Vehicle Maintenance Bulletin

UNITED STATES POSTAL SERVICE VEHICLE MAINTENANCE

MACK TRACTOR SERVICE RECALLS AND BULLETINS

Date: November 20, 2006
Number: V-01-07
Subject: Mack Tractor Service Recalls and Bulletins
To: Managers, Operations Programs Support
Attn: Managers, Vehicle Maintenance
 Managers, Vehicle Maintenance Facilities

Figure 2
Air Manifold Pass-Through Connections

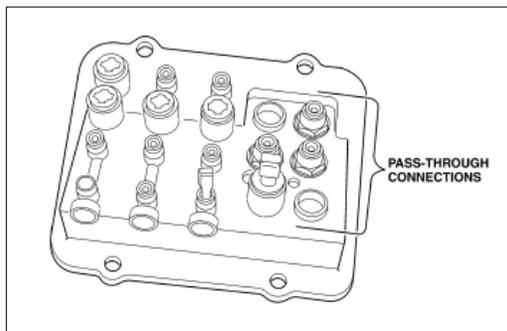
5. The manifold includes five large and three small pass-through holes. Depending upon chassis equipment, the large holes are used for certain air connections such as the fifth wheel air control switch, power take off (PTO) control valve, or air suspension control valve. The three small holes are used for exhaust lines, and for the supply line from the pressure protection valve to the dashboard air switches. Push-to-connect bulkhead fittings are installed in the large holes when used for pass-through connections and closure plugs are installed in any unused holes.

Clearly mark the air lines to identify the air lines connected to each of the pass-through bulkhead fittings and then use the push-to-connect release tool (Weather-head part number 1800TRK) to disconnect the lines from the fittings. The lines must be clearly marked to ensure they are reconnected to the correct ports on the replacement manifold.

Figure 5
Cylinder Head Cover-Mounted Breather Relocation Kit and Drain Tube

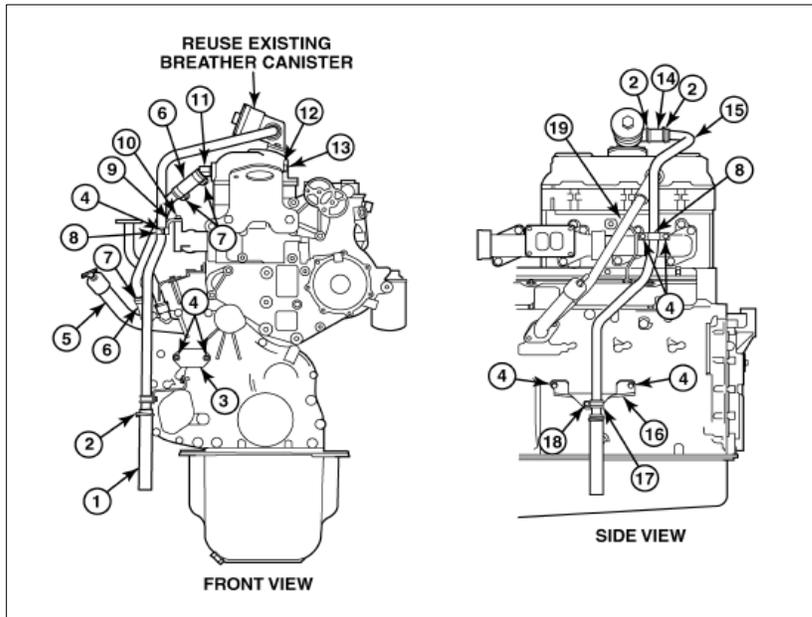
A revised cylinder head cover-mounted breather kit (part number 57GC524A) has been developed for chassis equipped with ASET AI, ASET AMI, and E-Tech engines used in certain vocational operations (predominately concrete mixers and dump trucks) to prevent oil from spilling out the breather tube when the vehicle is either backing up or slowly descending a steep grade. This revised kit, which replaces the original kit (part number 57GC523), incorporates an oil drain tube which allows oil that can flood the front cylinder head cover to drain back into the oil pan.

The kit includes all the components necessary to relocate the breather from the timing gear cover to the front cylinder head cover. The oil drain tube, which is different depending upon engine brake equipment, must be ordered separately. Refer to the illustration below and the accompanying parts table for a listing of the components contained in the kit.

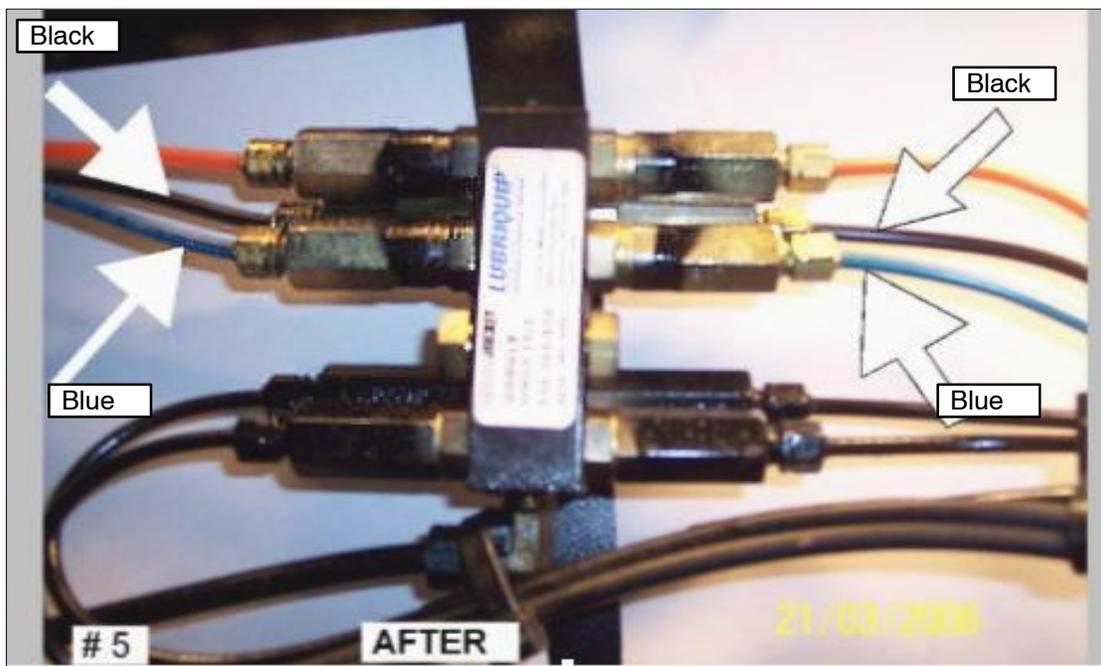
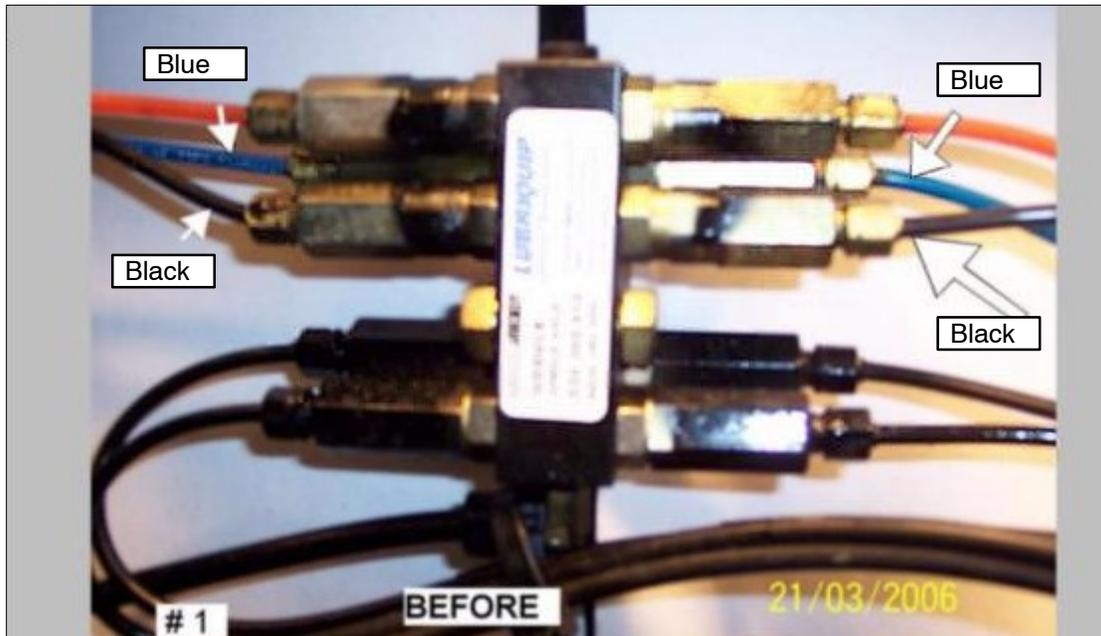
Check the lube fittings to the fifth wheel for proper routing. Reports have been received that the lube lines for the pivots and the rear plate lube ports are reversed. If the lines are improperly plumbed, the pivots will be over greased and the rear lube ports will not get enough grease.

The photos below show the lines improperly routed (before) and properly routed (after).

To correct the plumbing, reverse both of the blue and the black lube lines for the 5th wheel at the distribution block located inside the right side frame rail.

Figure 1 — Calculating Torque When Using Line Nut Torque Adapter

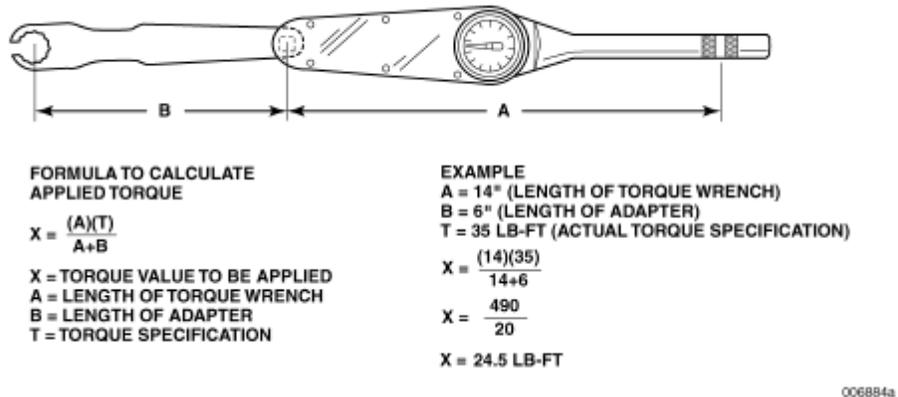
When using either the crow foot or the special line nut torque adapter, force applied to the torque wrench **MUST** be reduced according to the lengths of the wrench and adapter. Refer to the following illustrations for calculating the correct torque value.

The length of the adapter (dimension B in the diagram below) is 152.4 mm (6 inches). The injection line nut torque specification is 48 N•m (35 lb-ft).

Figure 4 — Aluminum Sleeve Installation (Upper Line Nut End)

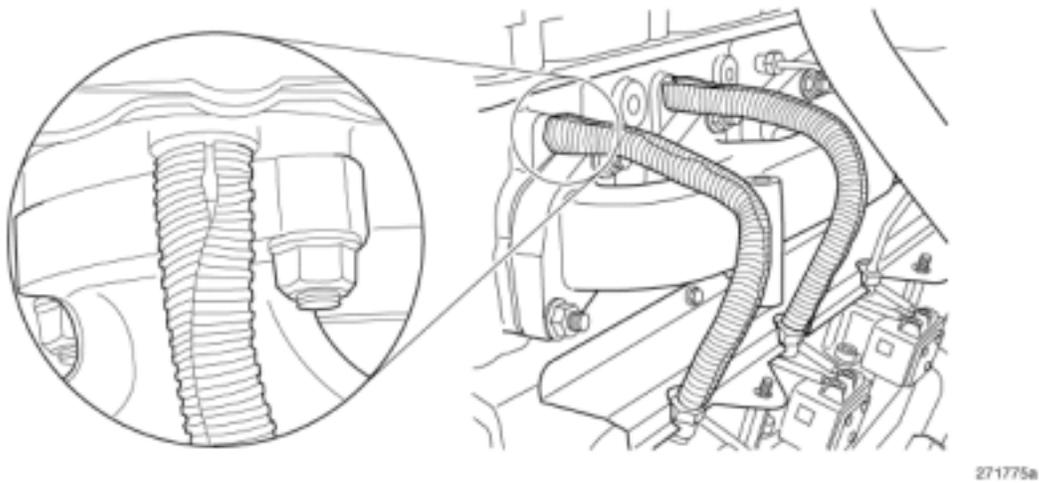
8. Install an aluminum sleeve over the No. 1 fuel line. The sleeve must be installed with the split facing upward over the exhaust manifold and outboard of the engine as it is routed along the line down to the unit pump. The upper end of the sleeve must cover as much of the line nut at the cylinder head as possible. Due to the size of the upper line nut, however, there will be a gap of approximately 6.35 mm (1/4") at the hex of the nut.

Figure 5 — Aluminum Sleeve Installation (Lower Line Nut End)

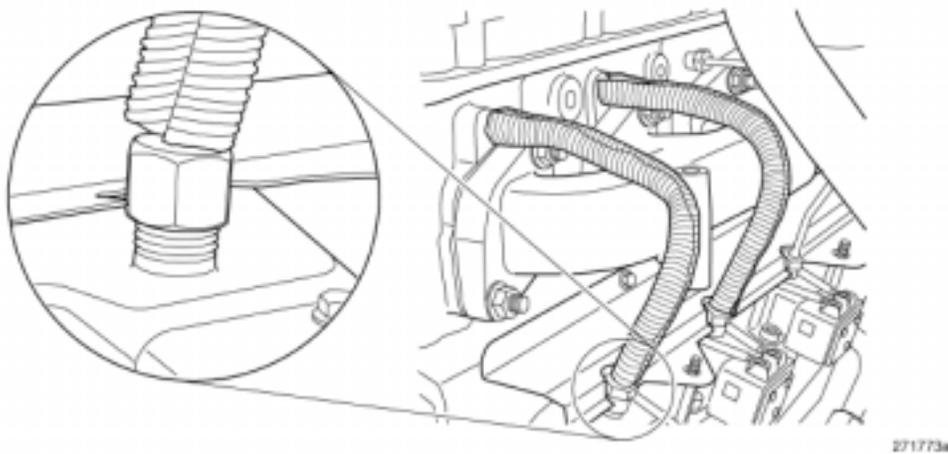
The lower end of the sleeve must be flush with the line nut, but must not cover the nut hex.

Exhibit 1 — Exhaust Manifold Heat Shield (Shown with Turbocharger Removed for Clarity)

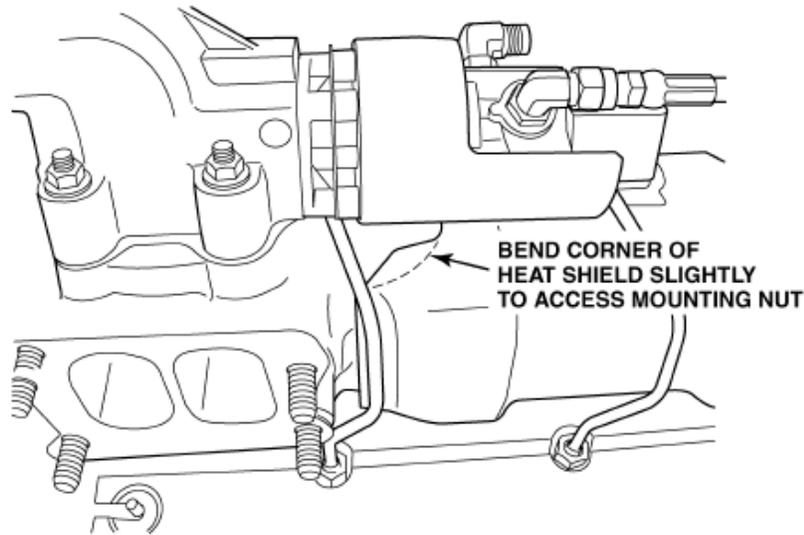
Note: Removal of the EGR valve and the turbocharger is NOT necessary. A 3/8" drive 18 mm thin-wall, deep-well socket and an extension should be used to remove and install the nuts. On some engines, the front exhaust manifold heat shield may prevent access to the upper front mounting nut. If this is the case, the rear corner of the heat shield can be bent downward slightly to allow access (refer to the illustration below).

Note: If the stud should back out along with the nut; install a new stud (part No. 616GC279AM). A suitable stud remover/installer, such as MATCO tool no. SR101-12, 12 mm stud remover/installer, 3/8" drive, can be used. As an alternative, use the double nut method (using two part No. 157AM4 nuts jammed together). Apply RTV sealant (part No. 342SX33) to the short threaded end of the stud and install the end of the stud with the sealant into the cylinder head. Tighten the stud until tight.
